Re: Preliminary Plat Review of the Pinewood Surf Club

Dear Hickman County Planning Commission and Chairman Callicott:

The Pinewood Church of Christ (photo above) and other nearby buildings were heavily damaged from floodwaters. The floodwaters were approximately 9 feet over the Pinewood Road bridge.

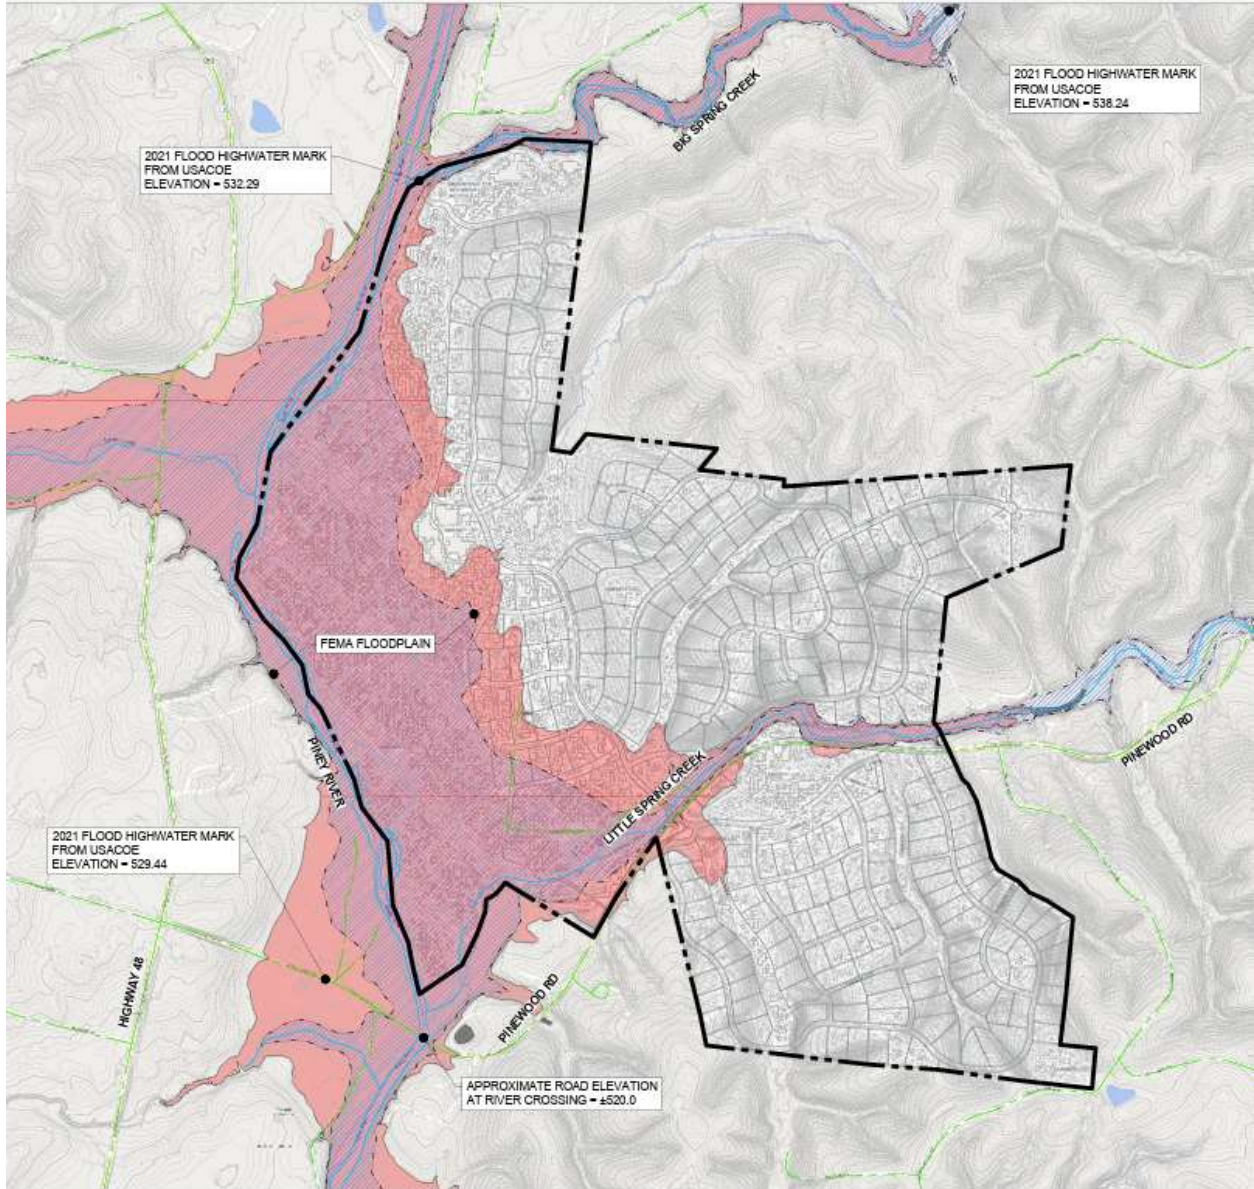
The August 21, 2021, flood that impacted the Piney River was part of the deadliest flood event to ever affect Middle Tennessee. The flood caused 20 deaths, 19 of which were in Waverly, Tennessee.<sup>12</sup> On the Piney in the exact vicinity of the proposed PSC, floodwaters shattered record flood heights and hit 31.8 feet compared to 20.08 feet set February 2019, according to NWS.

**Map 1:** Maps prepared by CDSG engineering off the sketch plat for Friends of the Piney. Red zone represents the 2021 flood based on flood measurements done by the Army Corp of Engineers. Blue, FEMA 2008 100-year floodplain.

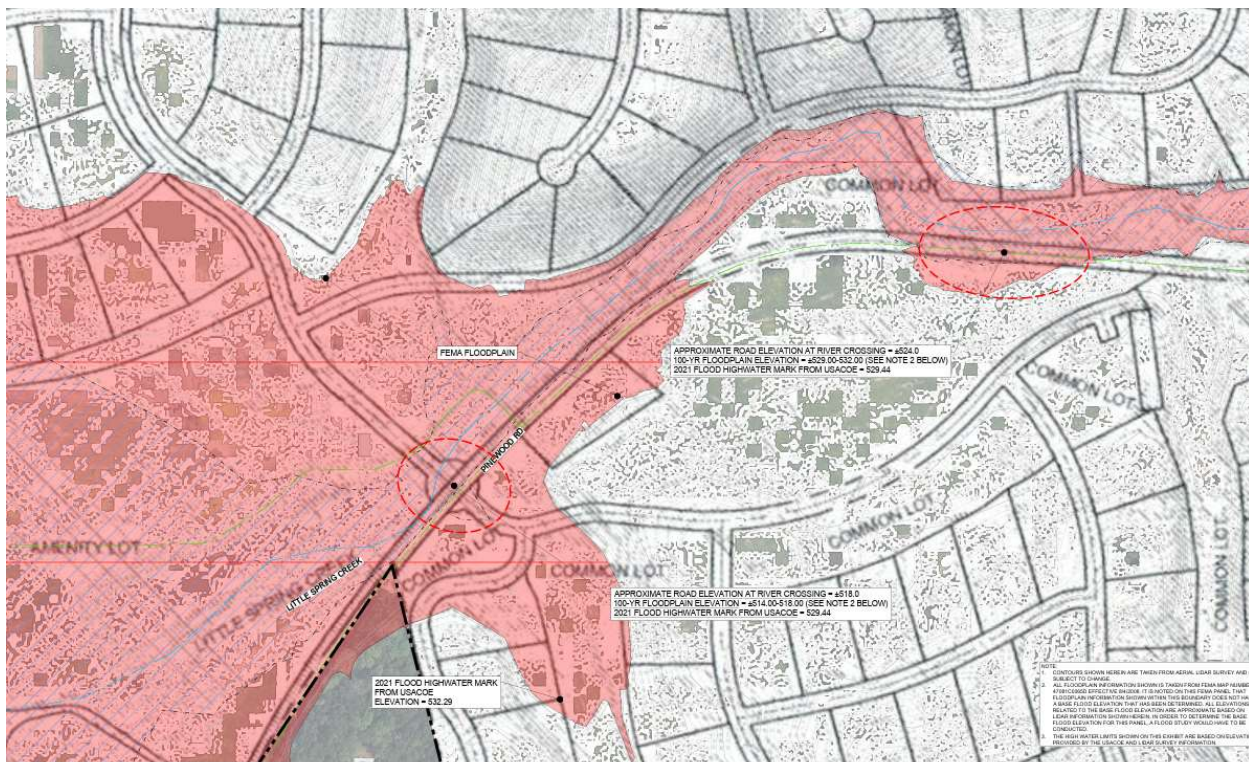
- State how floodwaters on Pinewood Road (depth up to 4 feet estimated, see Map 3 in Appendix A) will be reduced or eliminated to address road safety and public safety.

The depth of the 100-year floodplain water on Pinewood Road is estimated to be 4 feet based on the 2008 FEMA flood map (*see* Map 3 in Appendix A). In reality, this depth will be higher and the best way to calculate that height (and determine flood risk) is to use the more appropriate/updated flood statistics. The risk of people being stranded or driving into floodwaters on the road with over 1,000 residents and guests in this flooding area is greatly increased. Of all flood fatalities over the past 11 years (2010-2022), “driving” was—by far—the most common activity victims were performing.<sup>8</sup> In addition, emergency vehicles can get
